Product Change Notice (PCN)

PCN Number: PCN-0365225R-01

Product(s) Affected: SDI36-U & SDI35-UD Series

Current

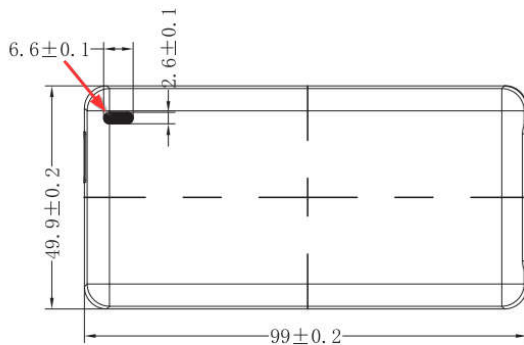
Reason(s) for Change: LED lens case tool update.

Description of Change: Size of LED lens shortened for concentrated light signal.
